From: [Phan, Johnny](#)
To: [Downtown West Project](#)
Subject: FW: Letter re SSE additional comments to revised DTW project documents
Date: Thursday, May 27, 2021 4:12:21 PM
Attachments: [Letter to City Attorney re Additional Comments to DTW Project Documents \(5-20-21\) \(10605086xD701E\).pdf](#)
[REDLINE of Exhibit K to Development Agreement \(Revised 5.20.21\) \(10605088xD701E\).pdf](#)
[Arena Parking Design Criteria \(5-20-21\) \(10605089xD701E\).pdf](#)
[Exhibit K to Development Agreement \(Revised 5.20.21\) \(10605065xD701E\).docx](#)
[Arena Parking Design Criteria \(5-20-21\) \(10605051xD701E\).doc](#)
Importance: High

ARENA PARKING DESIGN CRITERIA
For Parking Structures Providing Shared Use Parking for Arena Events

Exhibit K

Re: **SSE Initial Comments on Documents for City Council Hearing of May 25, 2021
Downtown West Mixed-Use Project**

Figure 2

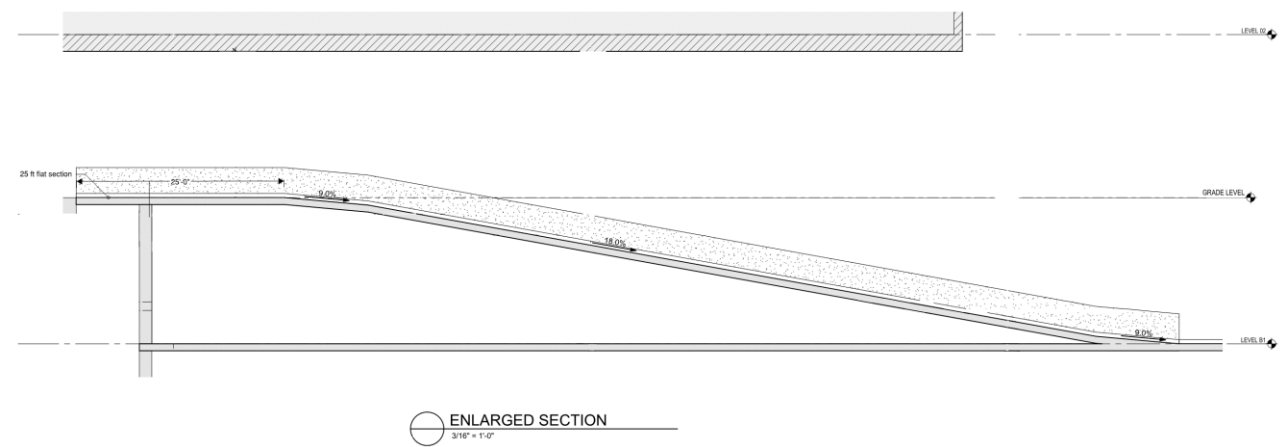
6. Provide ramping systems that efficiently accommodate peak traffic flows, including no parking on ramps and minimizing the number of turns and parked vehicles that a car must pass by to get to other floors. Ramps connecting a maximum of 3 levels in one path is assumed to be the best for accommodating high peak flows. Redundant ramps to facilitate flow should be considered in any facility that exceeds 500 spaces. Ramps that exit to the street should be designed per the City of San Jose Department of Public Works typical driveway profiles for below grade parking at a minimum (**see attached Figure 1**) or meet an approved solution that flattens out the ramp at the top to provide views of pedestrians crossing on the sidewalk for cars exiting the ramp. This may

include a flat section at the top of approximately 25 ft. before using an internal ramp slope, which design has been approved by the City on other projects (**see attached Figure 2**). Internal ramps should be designed with an 18% maximum slope with 9-10% blends at the top and bottom.

Figure 2

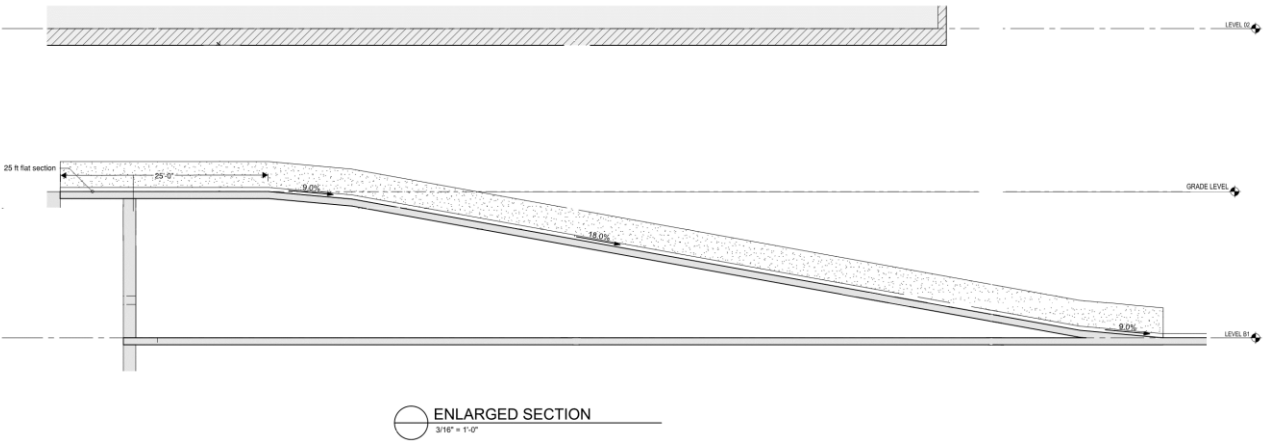
6. Provide ramping systems that efficiently accommodate peak traffic flows, including no parking on ramps and minimizing the number of turns and parked vehicles that a car must pass by to get to other floors. Ramps connecting a maximum of 3 levels in one path is assumed to be the best for accommodating high peak flows. Redundant ramps to facilitate flow should be considered in any facility that exceeds 500 spaces. Ramps that exit to the street should be designed per the City of San Jose Department of Public Works typical driveway profiles for below grade parking at a minimum (**see attached Figure 1**) or meet an approved solution that flattens out the ramp at the top to provide views of pedestrians crossing on the sidewalk for cars exiting the ramp. This may

include a flat section at the top of approximately 25 ft. before using an internal ramp slope, which design has been approved by the City on other projects (**see attached Figure 2**). Internal ramps should be designed with an 18% maximum slope with 9-10% blends at the top and bottom.
